Exhibit A1  
Staff Report  
Frog Pond Terrace 19-Lot Subdivision

Development Review Board Panel 'B'  
Quasi-Judicial Public Hearing  
**Adopted August 22, 2022**

<b>Application Nos.:</b>	DB22-0003 Frog Pond Terrace 19-Lot Subdivision <ul style="list-style-type: none"><li>- Annexation (ANNX22-0002)</li><li>- Zone Map Amendment (ZONE22-0003)</li><li>- Stage 1 Preliminary Plan (STG122-0003)</li><li>- Stage 2 Final Plan (STG222-0003)</li><li>- Site Design Review of Parks and Open Space (SDR22-0003)</li><li>- Tentative Subdivision Plat (SUBD22-0002)</li><li>- Type C Tree Removal Plan (TPLN22-0002)</li><li>- Abbreviated SROZ Map Verification (SROZ22-0005)</li><li>- Abbreviated SRIR Review (SRIR22-0003)</li></ul>
<b>Request/Summary:</b>	The requests before the Development Review Board include Annexation, Zone Map Amendment, Stage 1 Preliminary Plan, Stage 2 Final Plan, Site Design Review of Parks and Open Space, Tentative Subdivision Plat, Type C Tree Removal Plan, Abbreviated SROZ Map Verification, and Abbreviated SRIR Review
<b>Location:</b>	7480 and 7500 SW Frog Pond Lane. The property is specifically known as TLID 2800, 2801, and 3500, and a portion of SW Frog Pond Lane right-of-way

### Boeckman Creek Trail and Connections

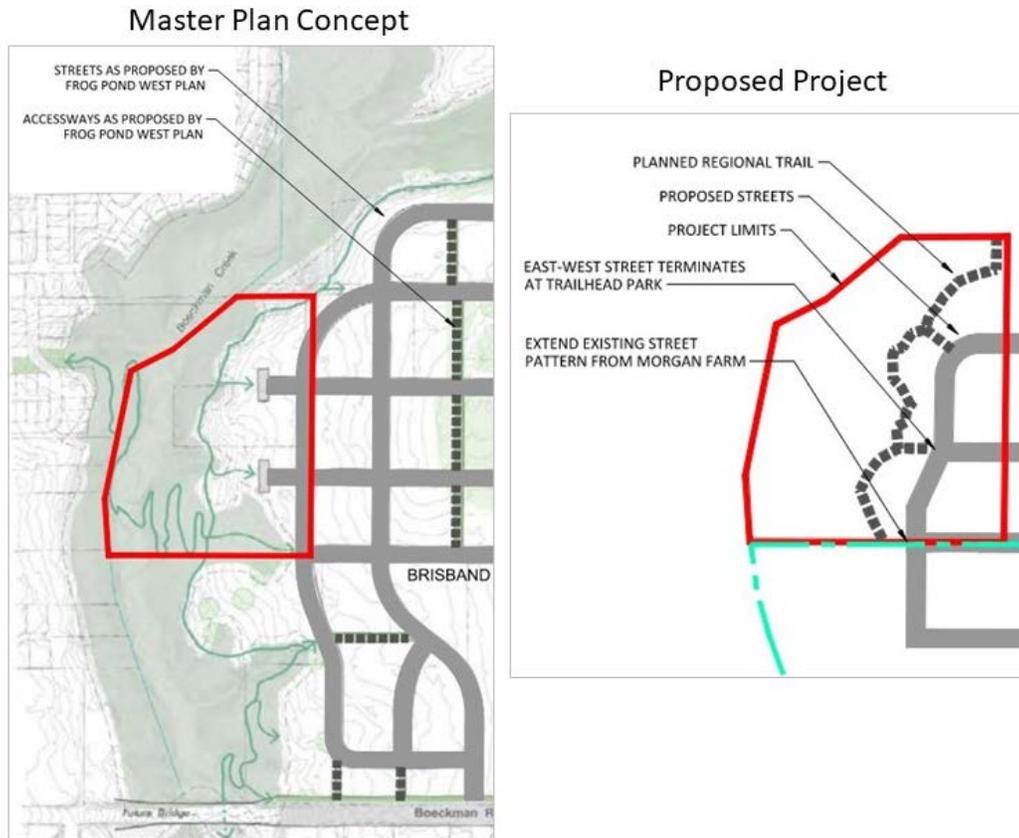
The applicant will construct a portion of the Boeckman Creek Regional Trail along the western portion of the property. As noted in the Frog Pond West Master Plan, this trail will run along the western edge of the Frog Pond neighborhood, with access provided via trailheads at the termination of east-west streets in Frog Pond. The Boeckman Creek Regional Trail will be located in Tract A, an open space tract including the SROZ and adjacent areas. The applicant proposes dedication of this tract to the City of Wilsonville. A Condition of Approval ensures that the dedication of this tract does not take place until environmental site assessments are completed and provided to the City.
